DRB CASE ACTION LOG - BLUE SHEET

Project #: 1010328 Application #: 15DRB-70129  
Project Name: Volcano Cliffs Subd.  
Agent: Wilson & Company Inc. Phone #:

**CITY OF ALBUQUERQUE  
PLANNING DEPARTMENT  
January 7, 2015  
DRB Comments**

**RE: Lots 2 & 3, Block 6, Volcano Cliffs, Unit 18**

LOT 2, BLOCK 6, UNIT 18  
VOLCANO CLIFFS SUBDIVISION

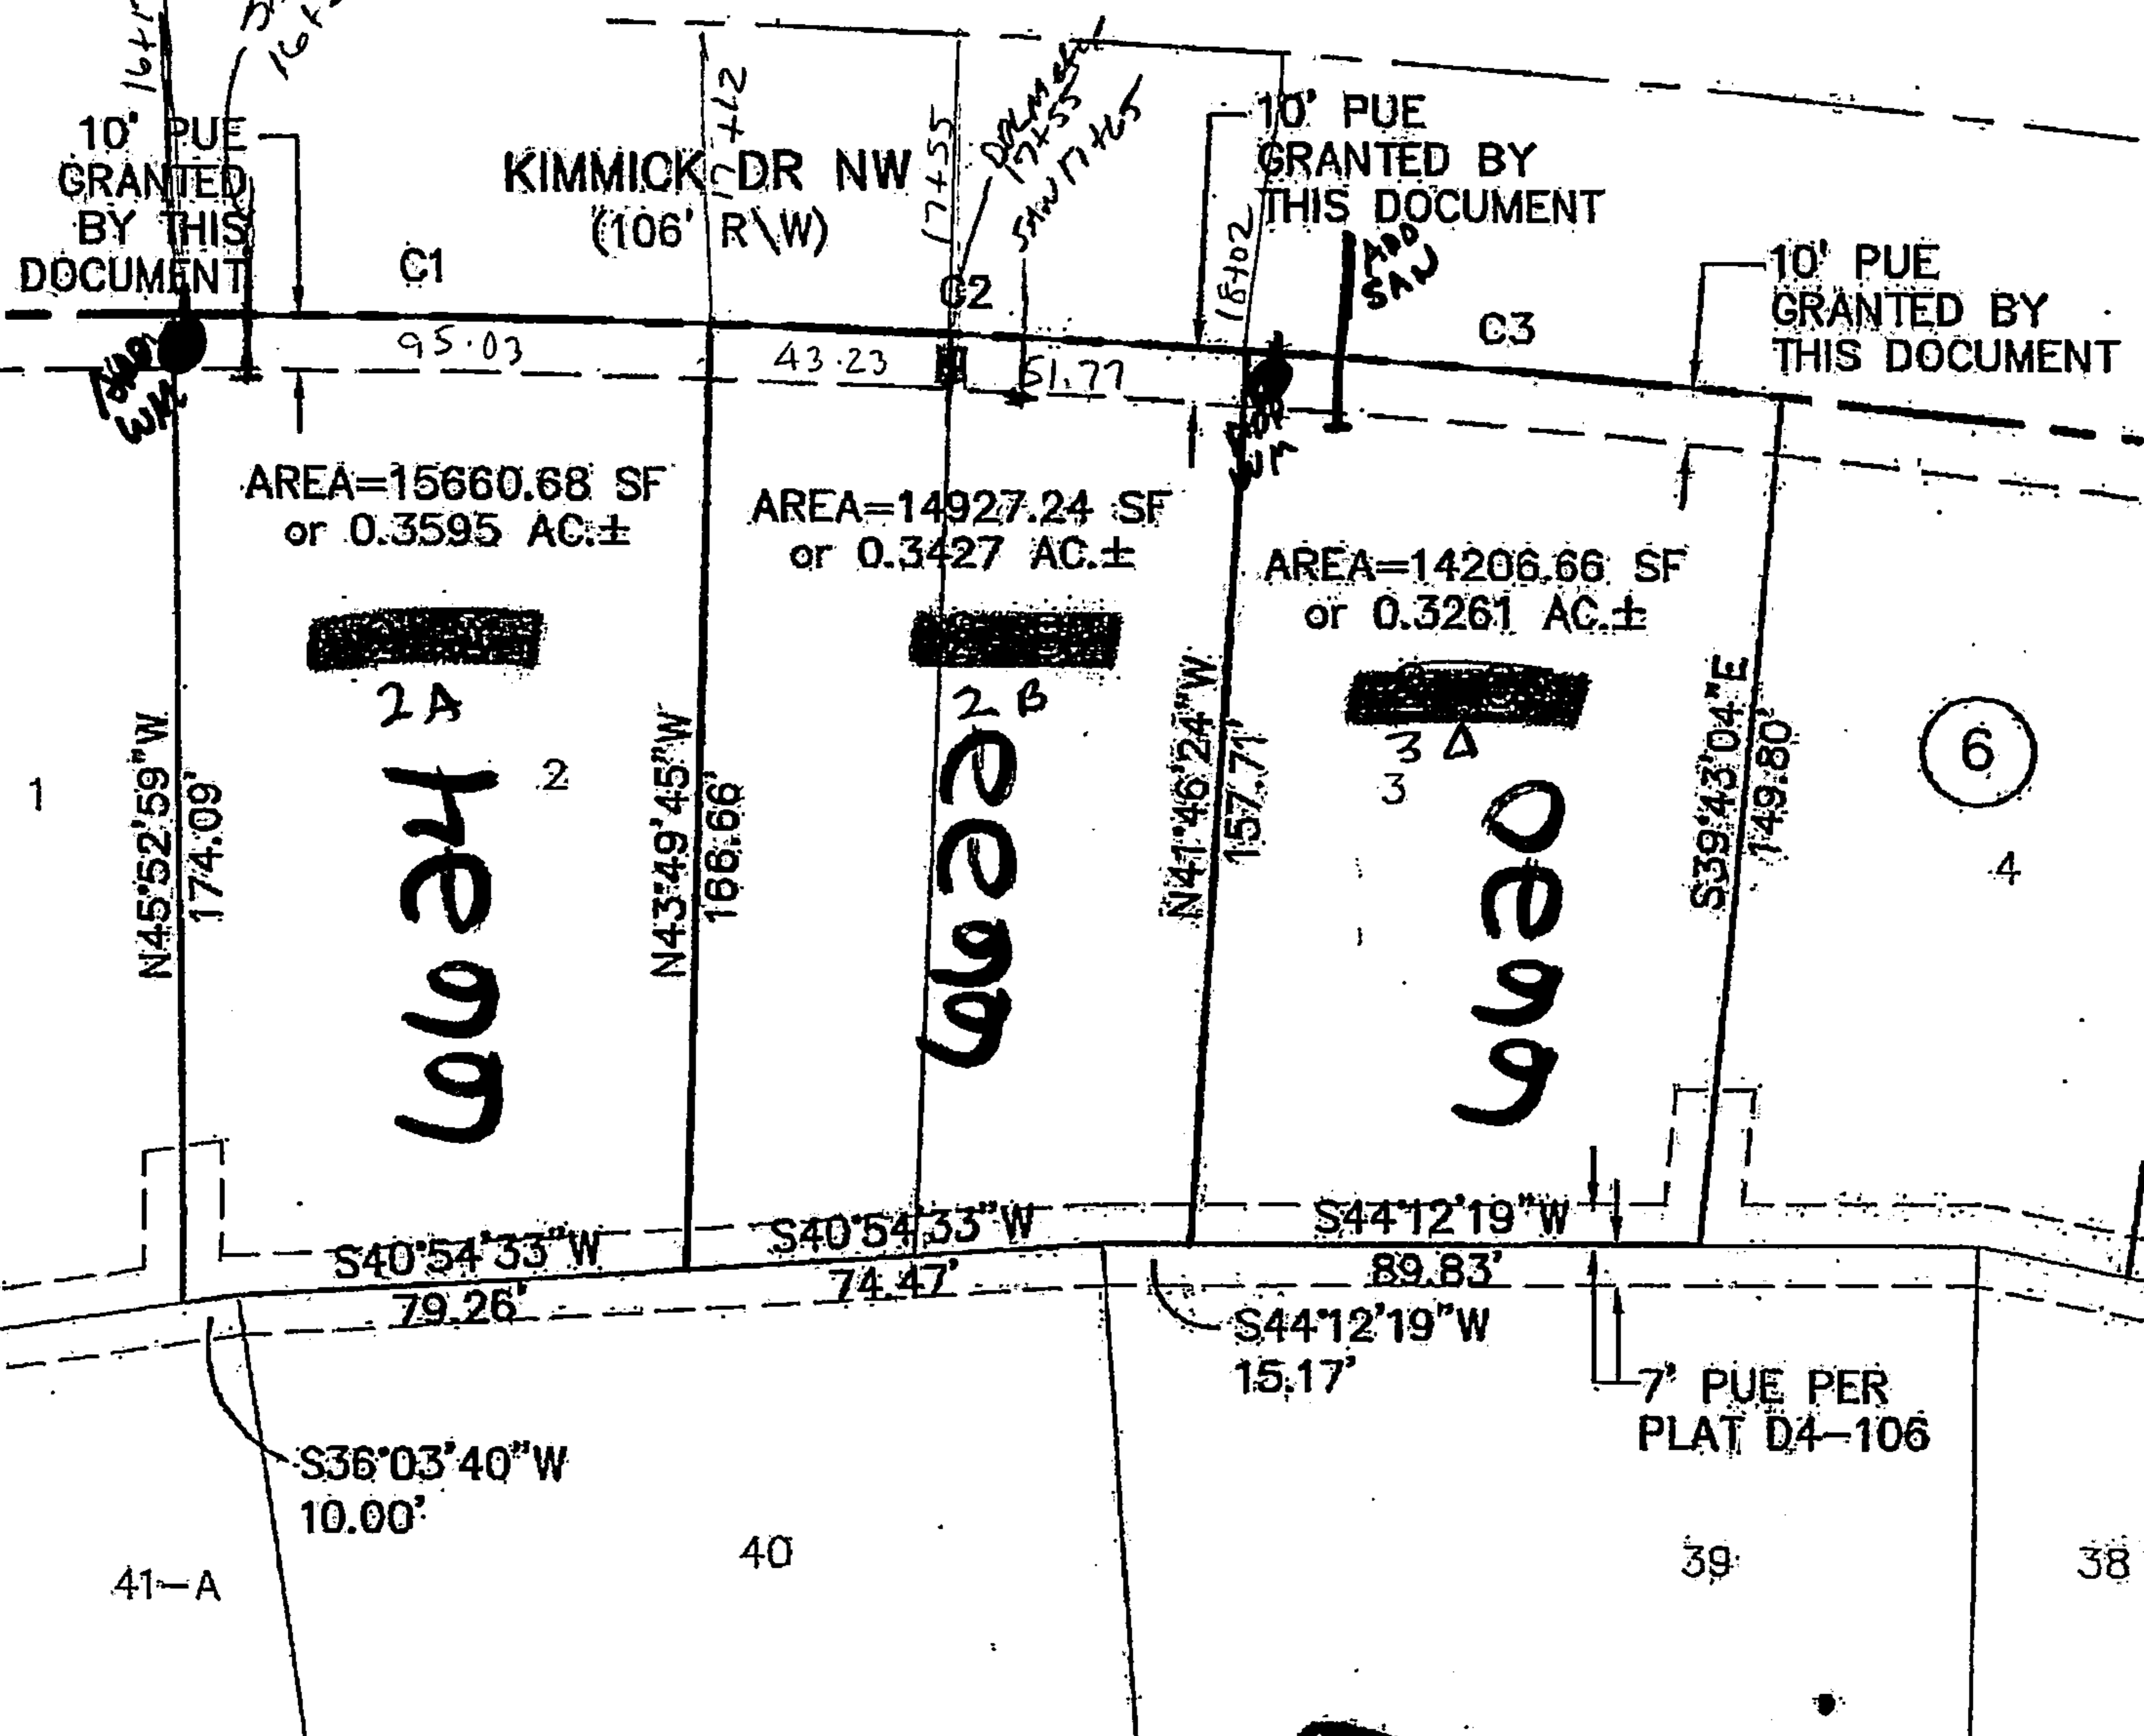
The site is zoned SU-2 VCLL; refer to NW Mesa Escarpment Plan/Impact Area & Volcano Cliffs Sector Development Plan for development standards (25' front setback and 15' for side and rear setbacks, bldg. articulation, bldg. height, garages, etc.).

Provide an exhibit showing the location of sidewalk and defining the distance from back of curb to the property line. Right of way dedication may be required.

Hydrology just has an informational comment:  
An approved grading and drainage plan is required  
for Building Permit approval, the infrastructure was  
built with SAD 228 and the lots are still large, ✓
